**East Side Coastal Resiliency Project:
Final Scope of Work to Prepare a Draft Environmental
Impact Statement**

April 5, 2019

CEQR No: 15DPR013M

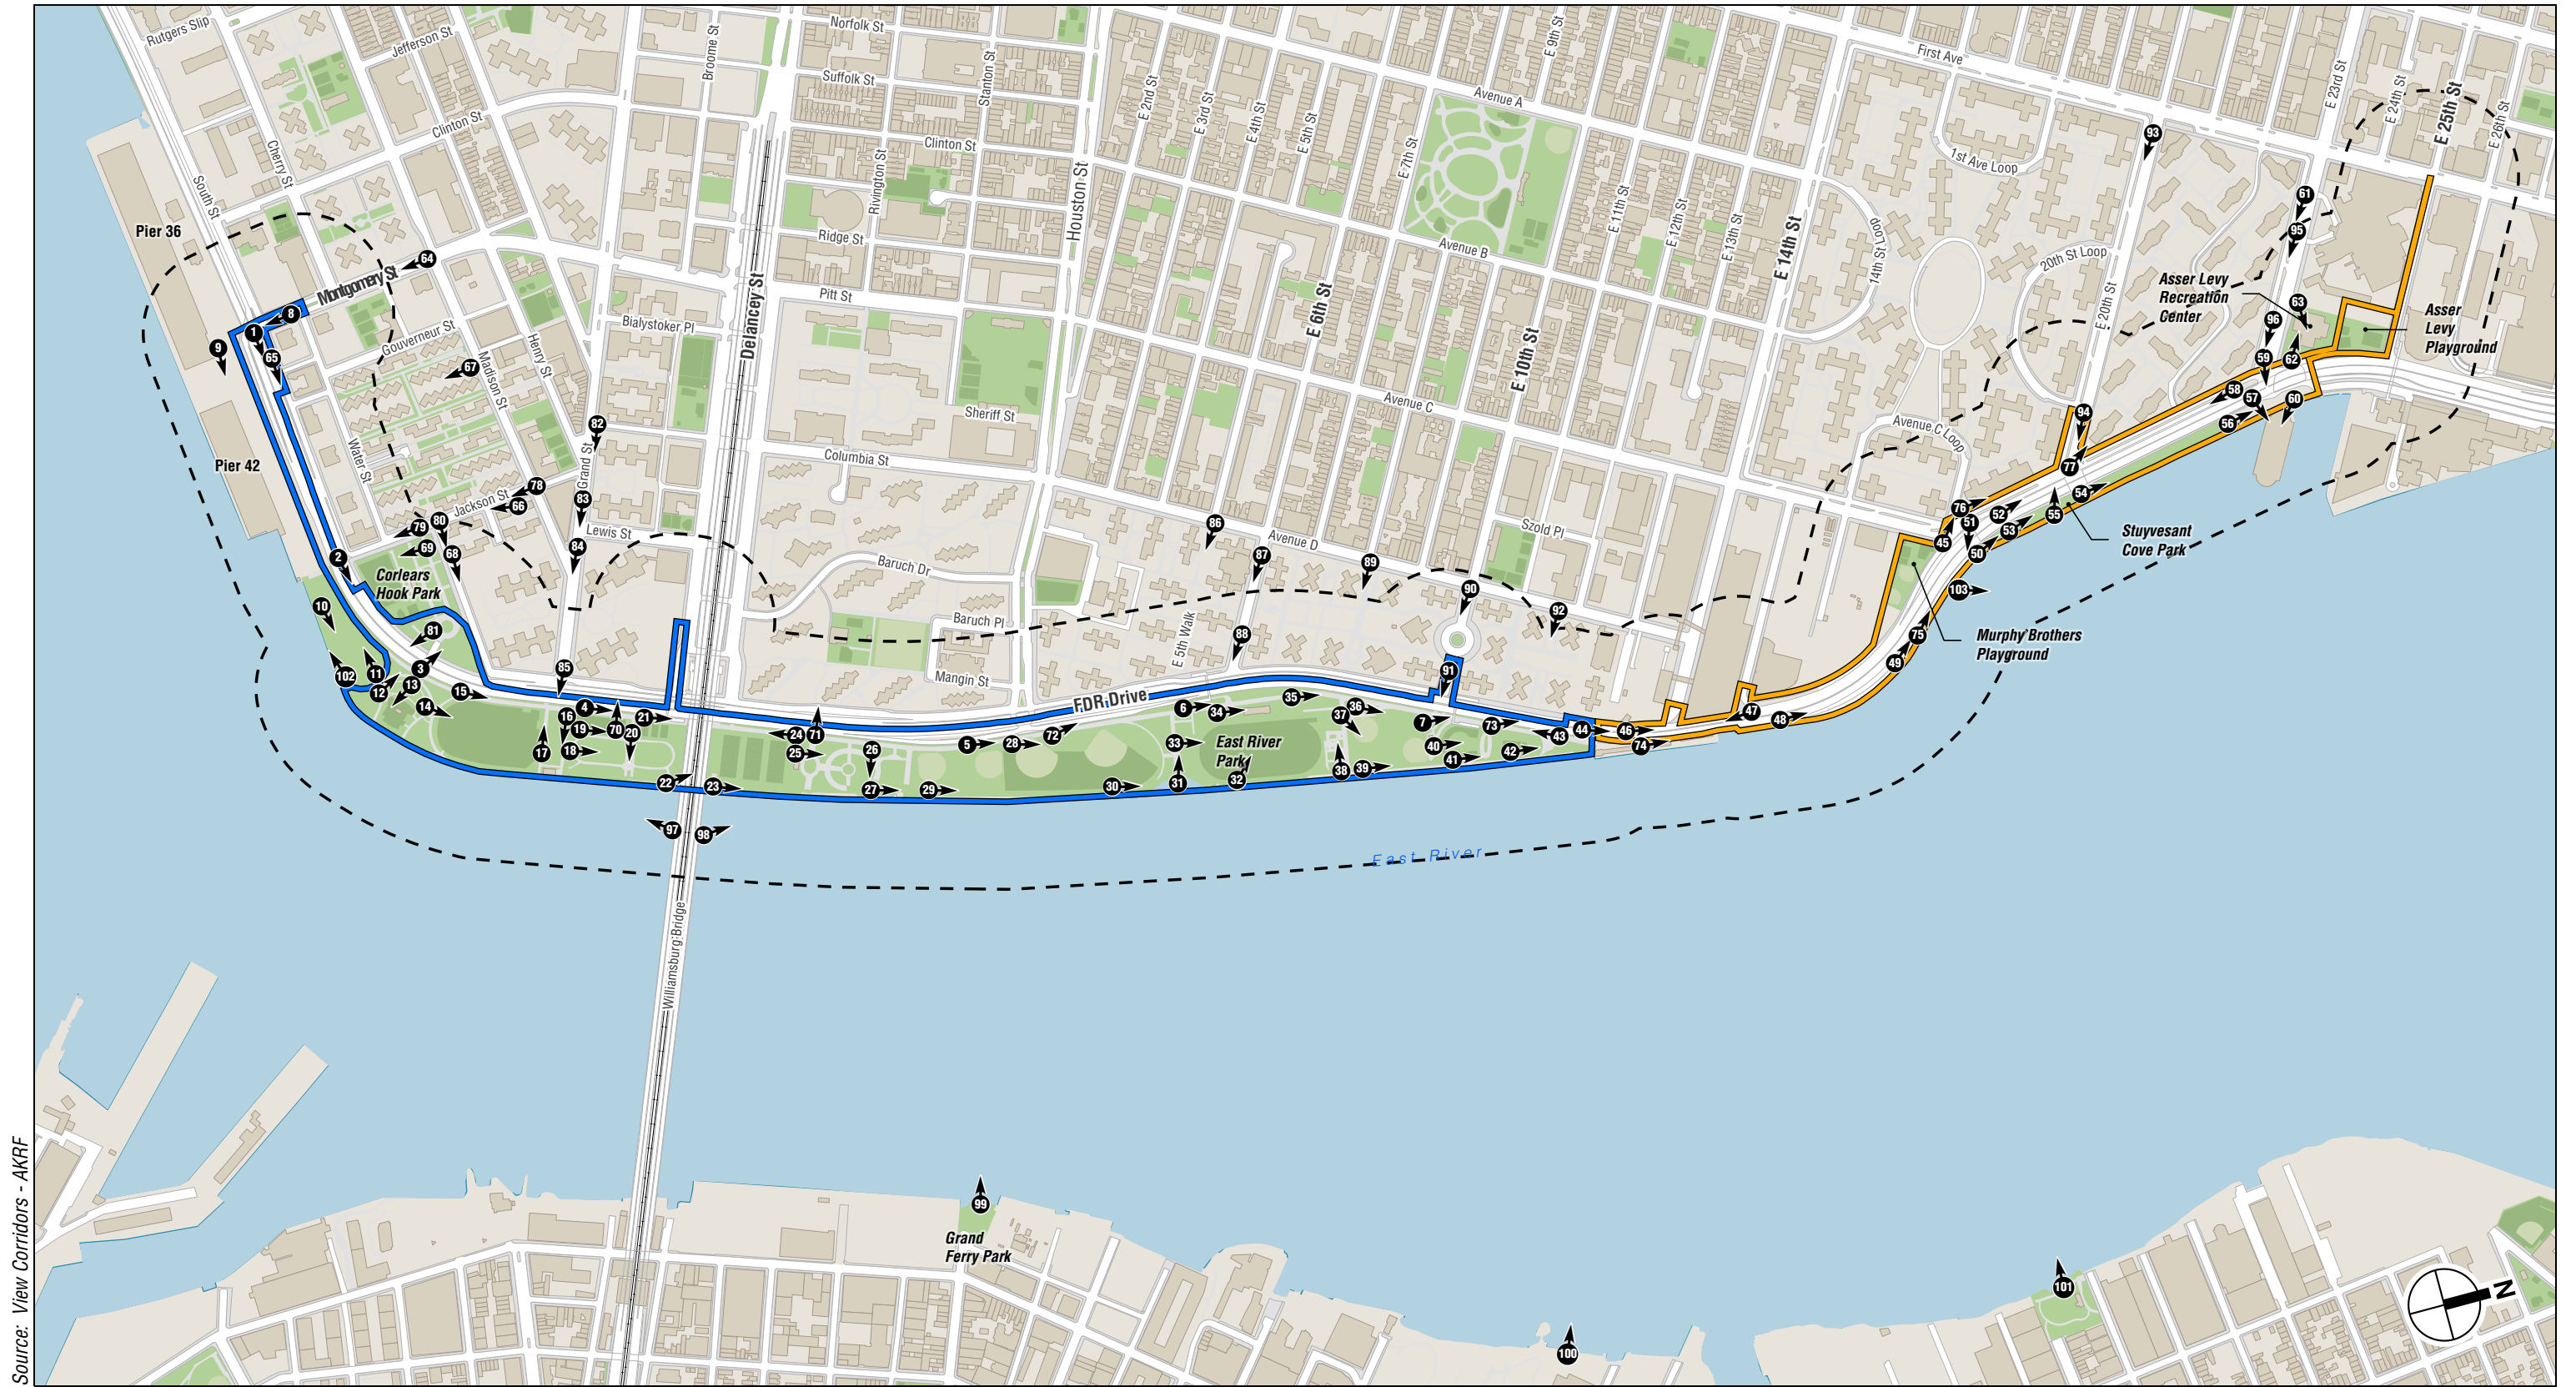
Street, Monroe Street, Market Street, and Cherry Street. In addition, the Draft Scope overlooks many officially designated NYC LPC landmarks, including Wheatworth Bakery (444 E. 10th Street), First Houses (112 E. 3rd Street), Congregation Beth Hamedrash Hagadol (242 E. 7th Street), the Public National Bank of NY (106 Avenue C), the 11th Street Public Bath (540 E. 11th Street) and an entire NYC Landmarks Preservation Commission-designated East 10th Street Historic District opposite Tompkins Square Park, that have been left off the draft map of historic and cultural resources (Figure 17). (Jensen)

Response: A comprehensive analysis of the potential impacts of the proposed project on historic resources will be presented in the EIS. The analysis will be prepared in accordance with Section 106 of the National Historic Preservation Act of 1966 (NHPA), as implemented by federal regulations appearing in 36 CFR § 800. The purpose of the Draft and Final Scope of Work is to provide the methodology for conducting the historic and cultural resources assessment to be provided in the EIS. Figure 19 in the Draft Scope of Work—Historic and Cultural Resources, Study Area—only provided a preliminary identification of known historic and cultural resources within a proposed 400-foot “Area of Potential Effect.” As described in the Draft and this Final Scope of Work, the EIS will include a comprehensive inventory of historic resources within this Area of Potential Effect that may be affected by the proposed project. This inventory will include potential architectural resources—properties that appear to meet National Register and/or New York City Landmark eligibility criteria—identified through a field survey by a qualified historian and archival research and considering public comments. The East River amphitheater and Rivington Street Baths will both be considered. As described in the Draft and this Final Scope of Work, the EIS will assess the potential impacts of each of the alternatives on the comprehensive inventory of known and potential architectural resources and the protections and the need for any mitigation measures.

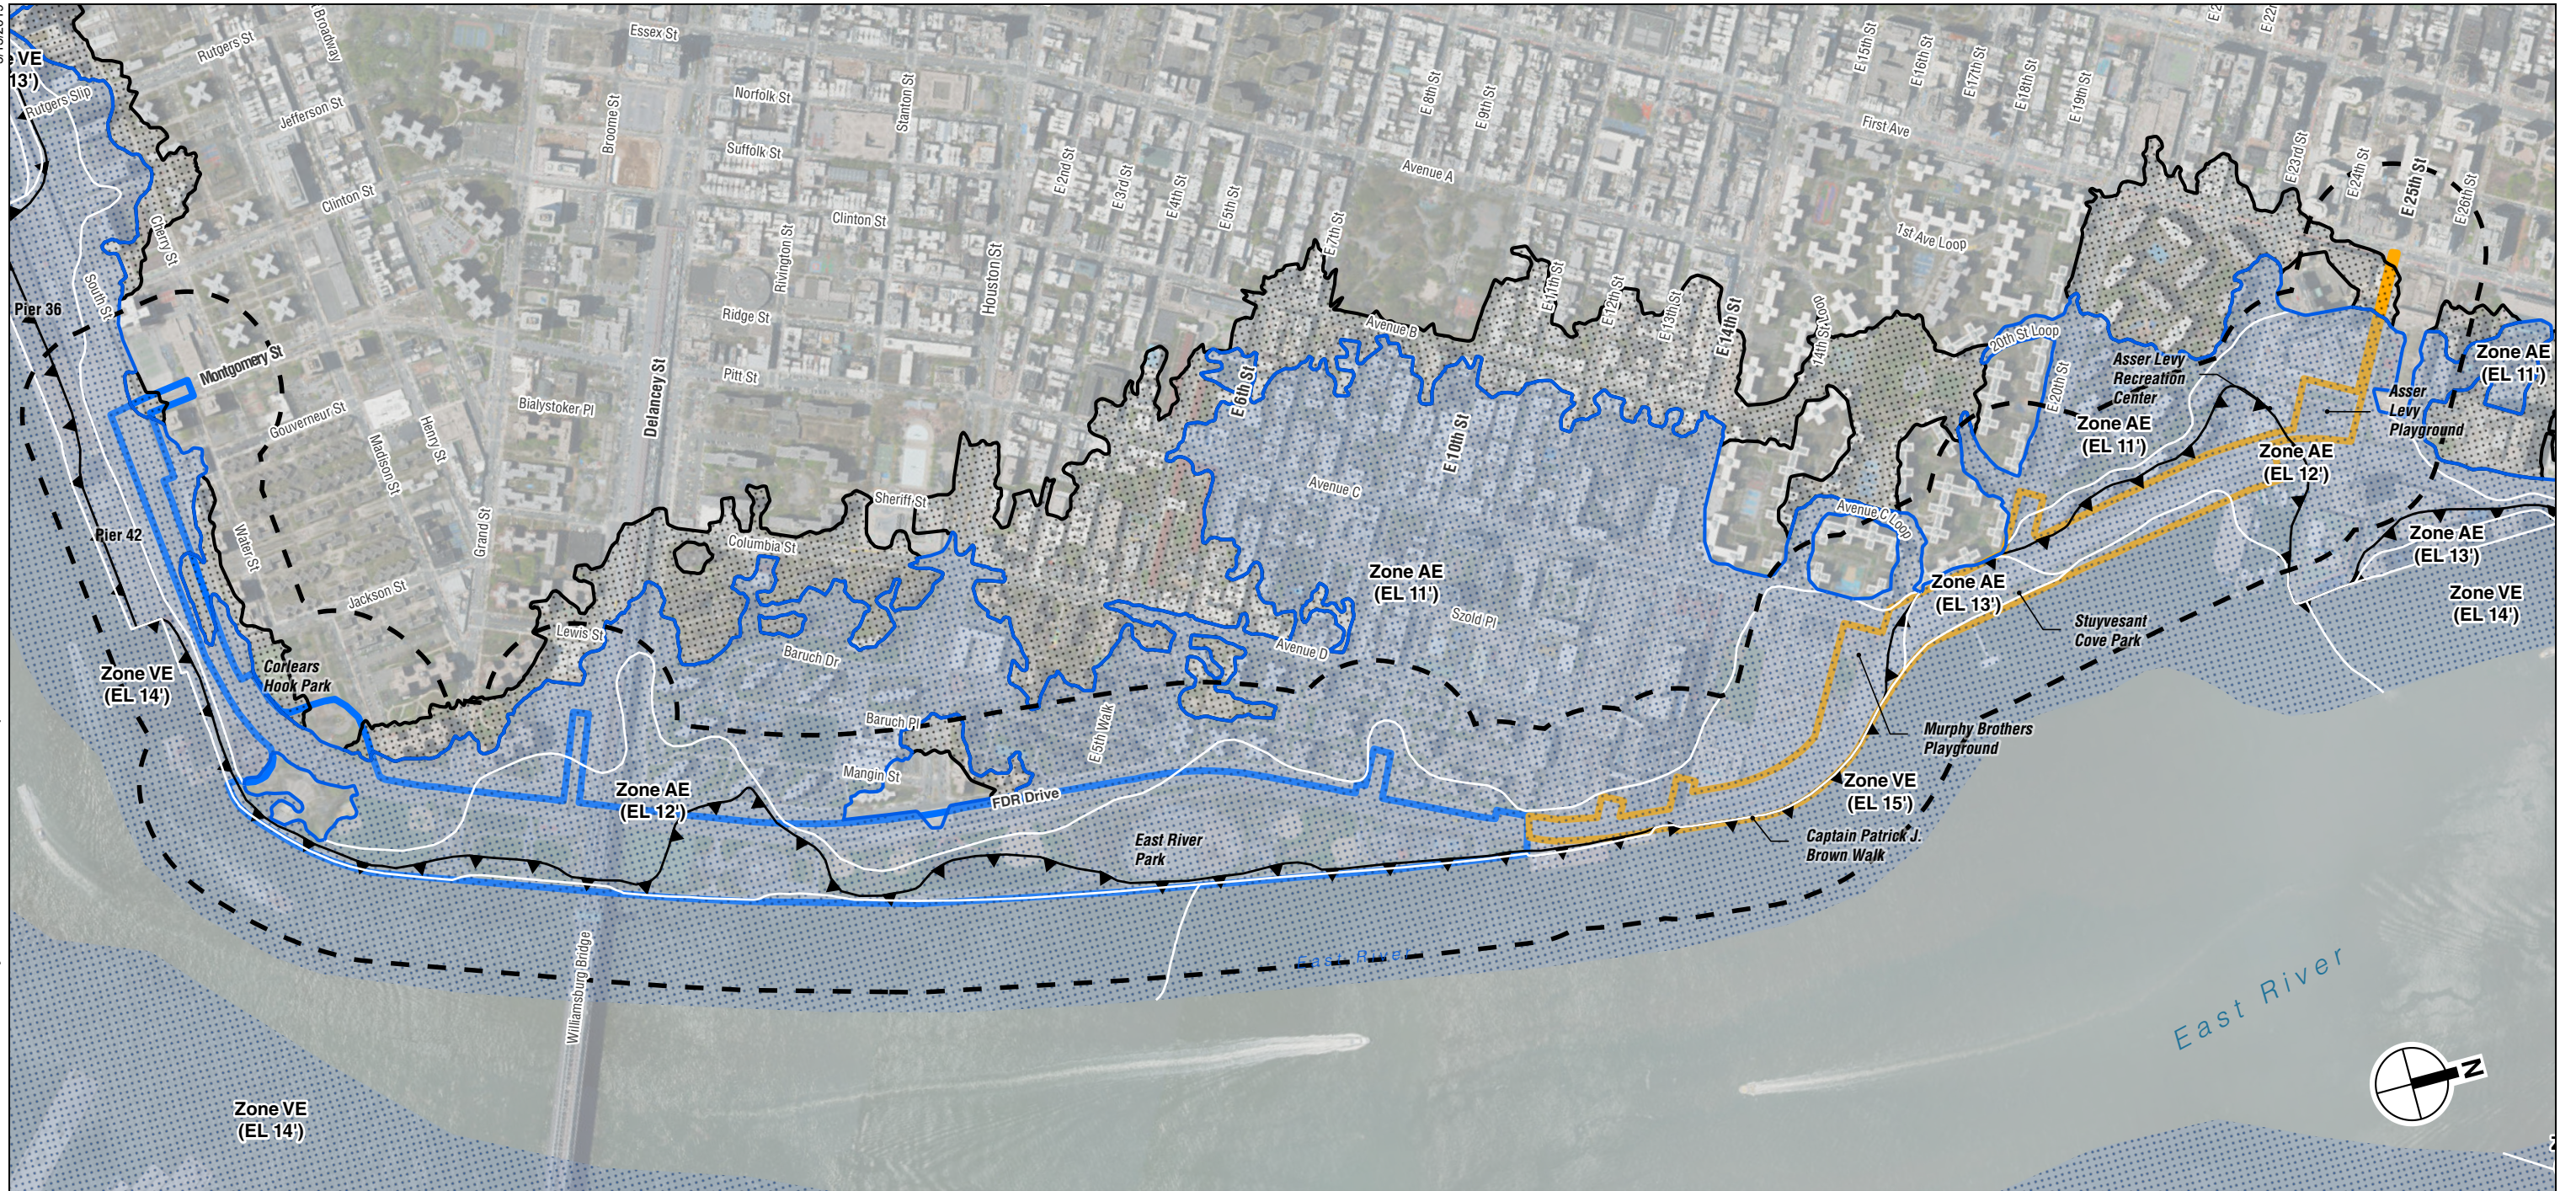
Comment 67: Correction to Figure 18: The northward Avenue C view corridor (toward the Queensboro Bridge) is an important view corridor, but here is not shown by any arrow in the drawing. I suggest that it be included and also include the direction that whatever deployables are going to be utilized are oriented so that this view corridor is preserved. (Scheyer)

Response: As described in the Draft Scope of Work, Figure 20—Urban Design and Visual Resources, Study Area and Visual Corridors—provided a preliminary identification of existing inland views to the waterfront. Figure 20 in this Final Scope of Work has been modified to include the northward view corridor from Avenue C, which will be evaluated in the EIS.
